Kansas Department of Agriculture
 Division of Water Resources
CHANGE: P/U WORKSHEET

DWR FIELD OFFICE APPLICATION FOR APPROVAL TO CHANGE THE PLACE OF USE AND/OR THE POINT OF DIVERSION

SUMMARY ORDER APPROVING APPLICATION FOR CHANGE AND IMPOSING CONDITIONS

RE: Applications for Change in Place of Use
Water Right, File Nos. 16157, 19820 D8, 20890, 22576 D2, 22576 D3, 22576 DA, 22576
DB, 22577 D1, 22578 D2, 24050, 28620, 28621 D2, 29855 D1, 29855 D2 & 30157

**CHANGE IN PLACE OF USE WATER RIGHT, FILE NOS. 16157;
 19820-D8; 20890; 22576-D2; 22576-D3; 22576-DA; 22576-DB;
 22577-D1; 22578-D2; 24050; 28620; 29855-D1; 29855-D2 & 30157**

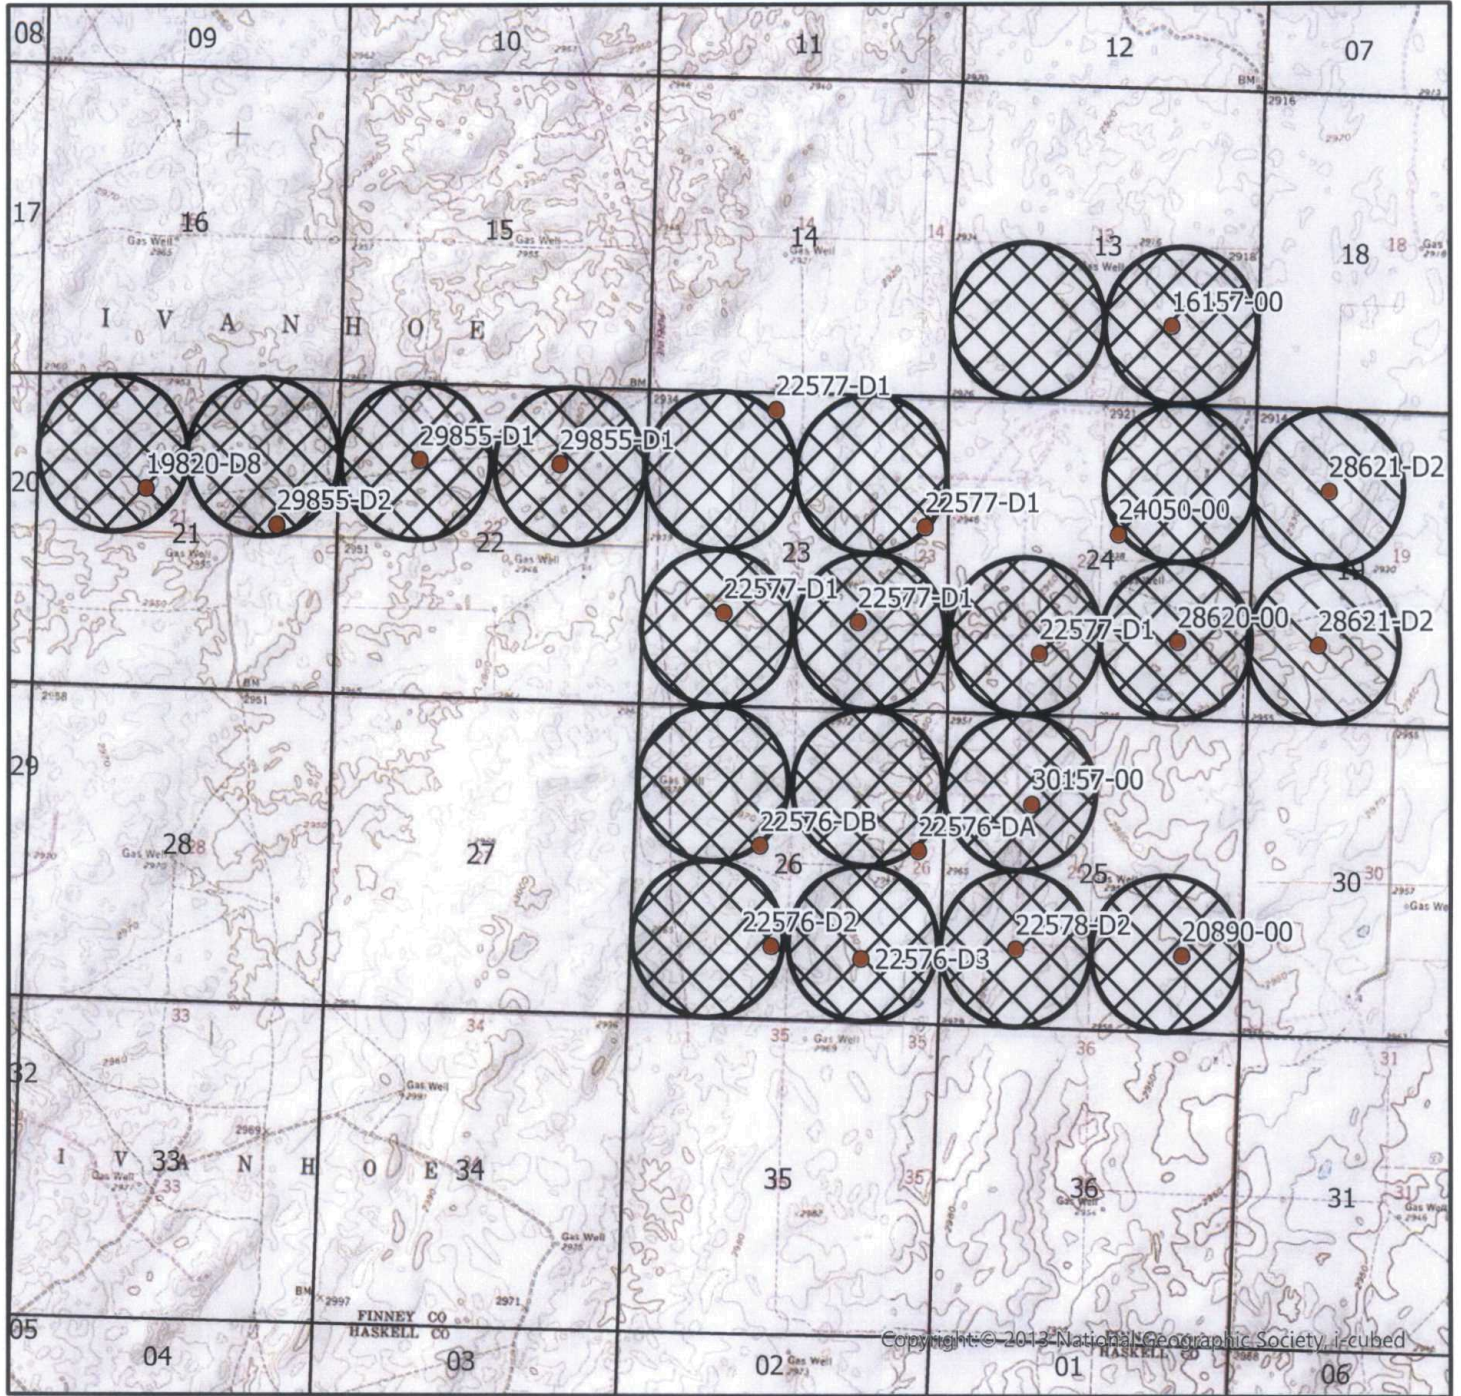
We have reviewed the applications for the above referenced water rights. The proposals are not in conflict with the Management Program of the Southwest Kansas Groundwater Management District No. 3 (GMD3). The proposed change in place of use will make a complete overlap in currently authorized place of use in accordance with K.A.R. 5-5-11(b). It is therefore recommended that the applications be approved at this time.

Is Proposed PU overlapping existing WRs? Bringing in 28621D2 acres to overlap with the rest that are already completely overlapped.

Currently the land and wells under 28621D2 stand alone. The proposed change will now overlap the PU with the other water rights for a complete overlap. No new acres are being proposed that are not currently authorized by a water right.

Recommendation: After review of all available information, it appears current area rules are met. Staff therefore recommends approval of the applications.
